Steepbank Mine Project

Supplemental Information Response

**SUPPLEMENTAL INFORMATION RESPONSE
STEEPBANK MINE PROJECT
EUB APPLICATION NO. 960439
AEP APPLICATION NO. 020-95, AND FILE NO. 27551**

The following information is provided in response to the Energy and Utilities Board and Alberta Environmental Protection supplemental information request dated July 12, 1996. The following response follows the outline of your supplemental request letter.

FIGURE 1-1

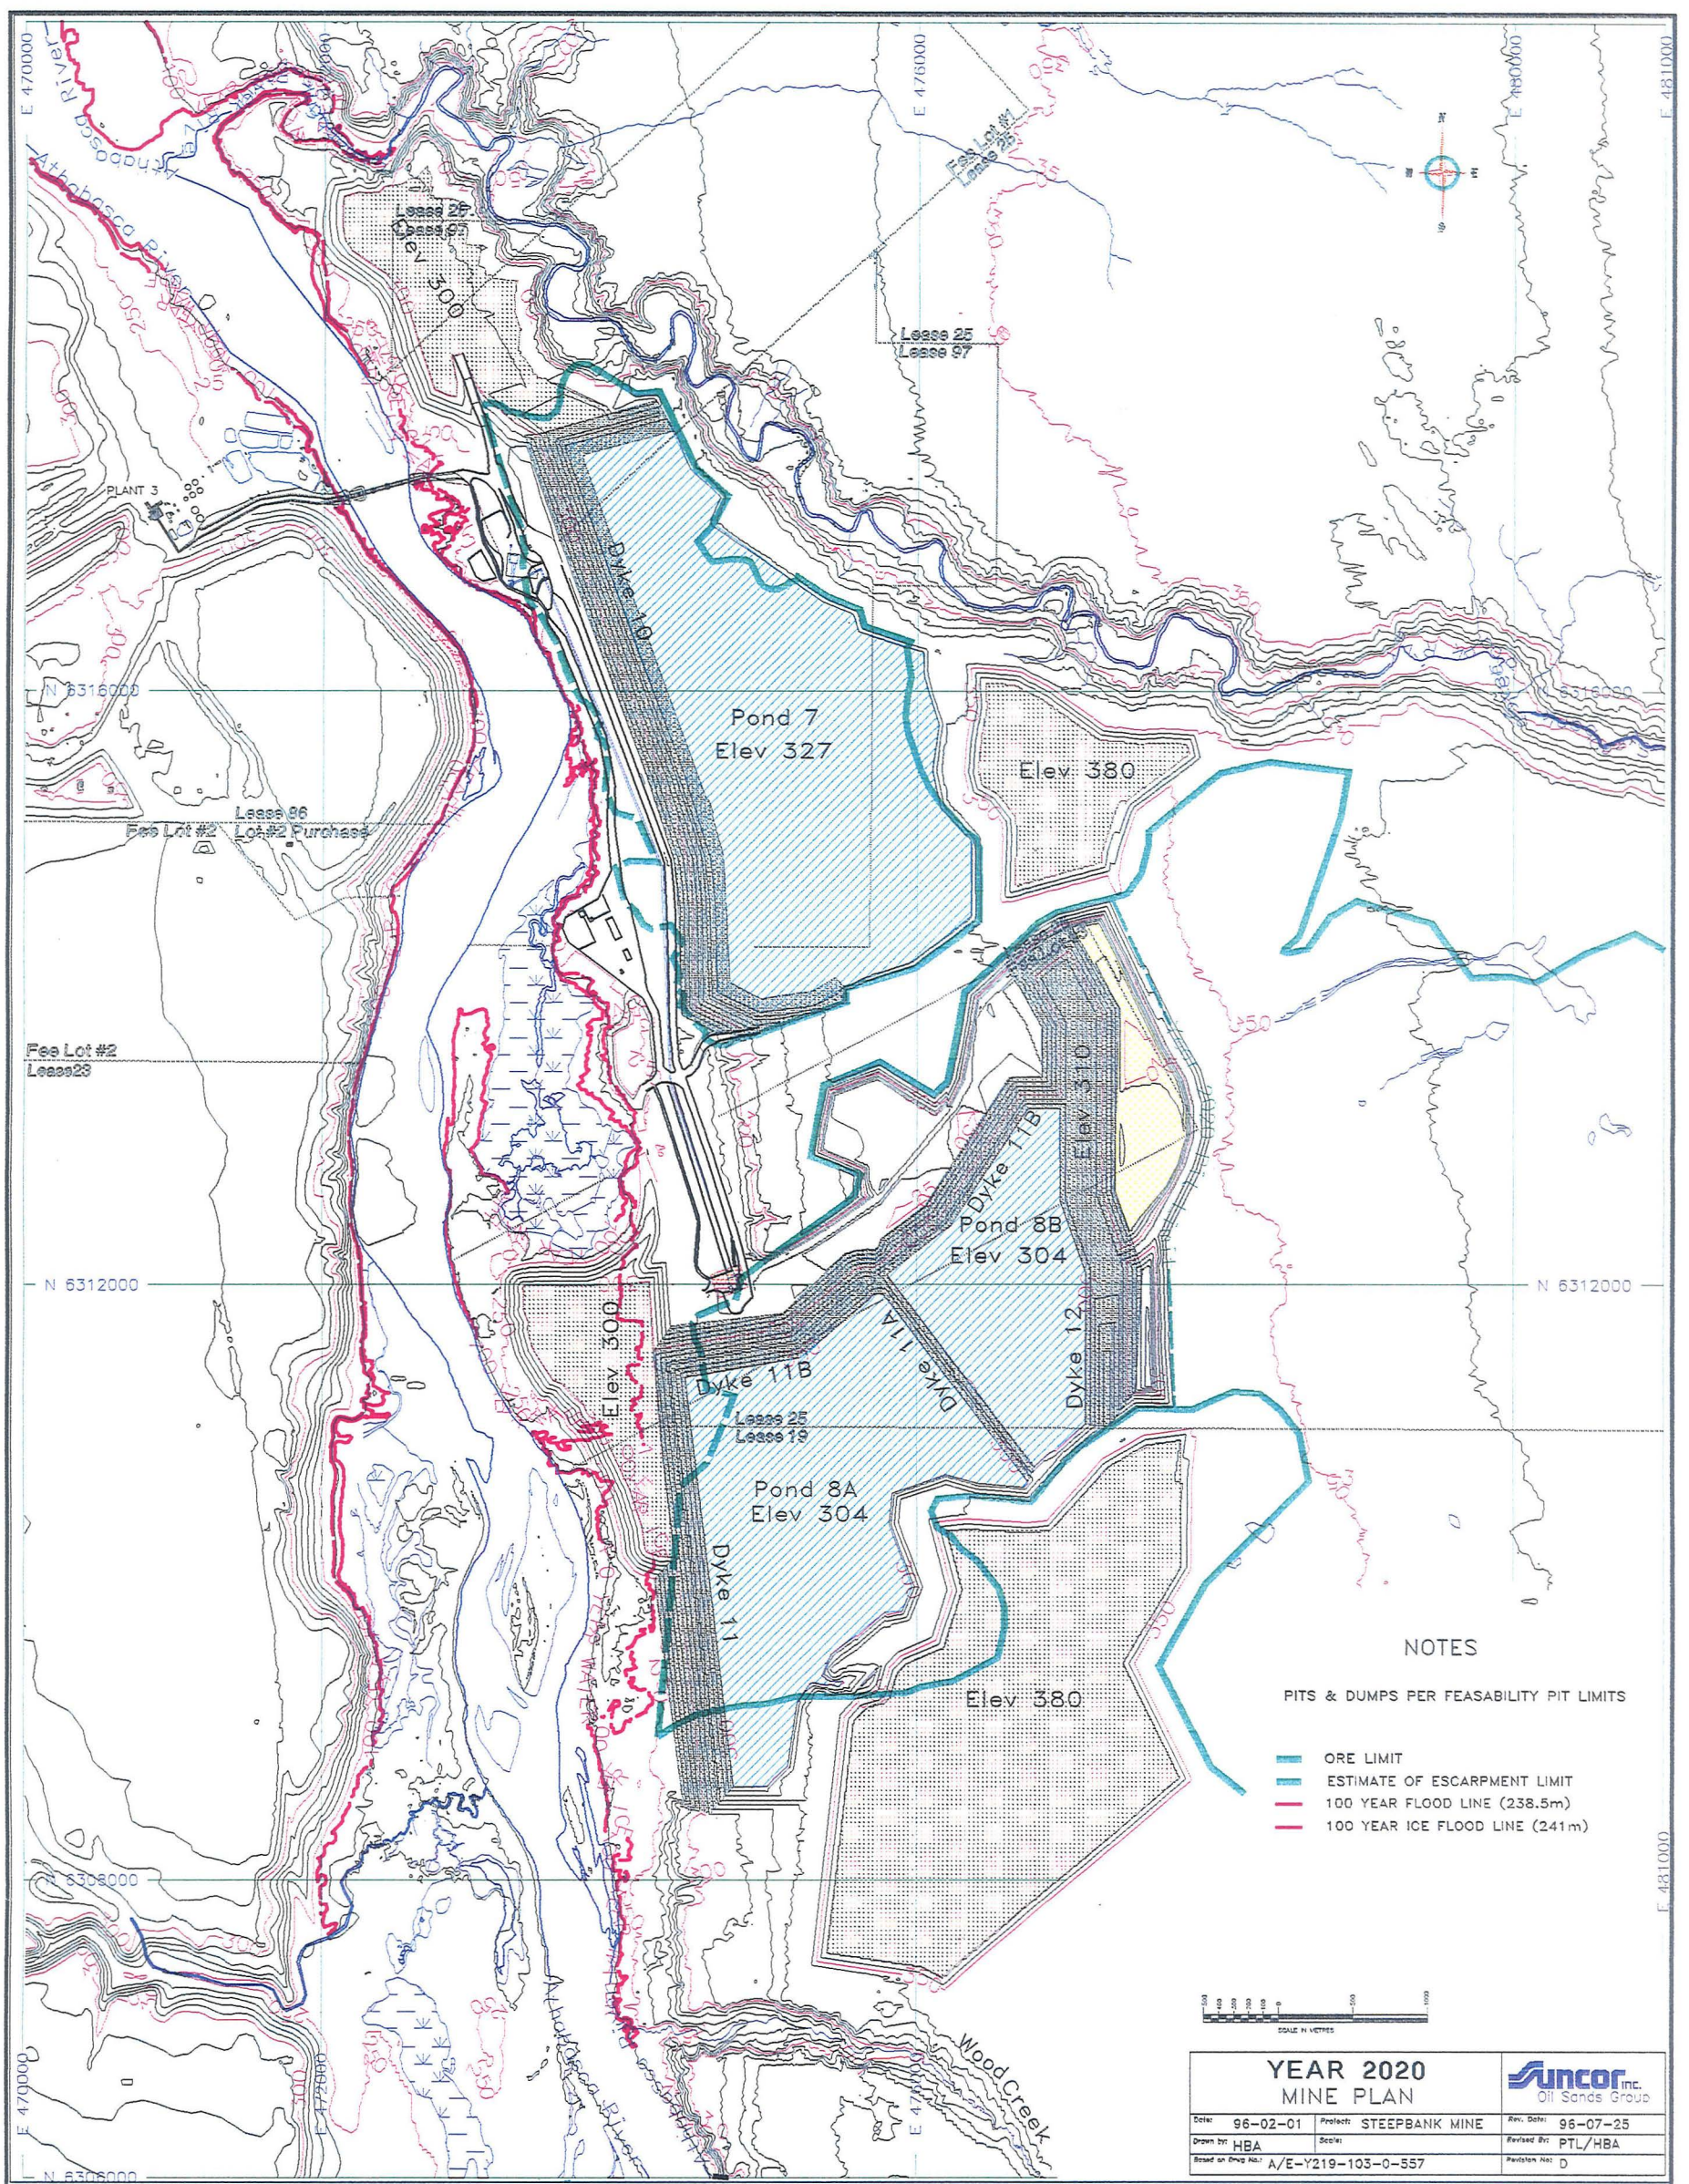
Q1.1 Provide an update on the design plans for the Steepbank Mine and associated infrastructure. Include any recent changes to the development plan which may have implications for environmental protection and resource conservation.

Mining boundaries as indicated on Figure 1-1, and particularly the escarpment daylight boundary, are still under revision pending additional exploration drilling, and topography mapping.

A1.1 The Steepbank Mine Application was based on feasibility level design for the project, the planning process has continued since the application was filed in April 1996.

Detailed engineering has begun, focussing on construction plans and mine layouts. Significant project changes, affecting the environment and resource conservation, are described below.

A decision was made in February 1996 following additional drilling and consultation with interested parties, to not mine ore in the northern peninsula area. The mine plan has now been reworked to exclude this area, and resulted in a loss of less than six months of reserves. The new mining boundaries are shown on Figure 1-1. There is still a requirement for an external waste dump in the peninsula area, primarily to hold the pre-stripping material for Pit 1. The waste dump is designed with a minimum setback from the Athabasca River of 200 meters, setback 100 meters from the valley break for the Steepbank River and overall slope of 3H:1V. The waste dump sides have been contoured to present a more natural landscape and will be revegetated as soon as practically as part of the valley reclamation plan. The toe of the dump will be located outside of the 1:100 year ice flood contour. The maximum height of the waste dump has not been finalized but, as shown in Figure 1-1, is anticipated to reach a height of 300 meters above sea level.

- A4.5c Facilities in the valley are located above the 1:100 year flood levels, following criteria in the Integrated Resource Plan. The relocation of the West Waste Dump to a location outside of Shipyard Lake wetlands resulted in a portion of this dump placed in the flood plain. The flood contours relative to the location of facilities are indicated on Figure 1-1.

A4.35 A contour map showing the flood contours in relation to mining boundaries and facilities siting is provided in Figure 1-1. Cross sections through the escarpment area are provided in Figures 4.5-1 to 4.5-3. These figures show that all mining activity, shaded in green, is well above the flood plain.
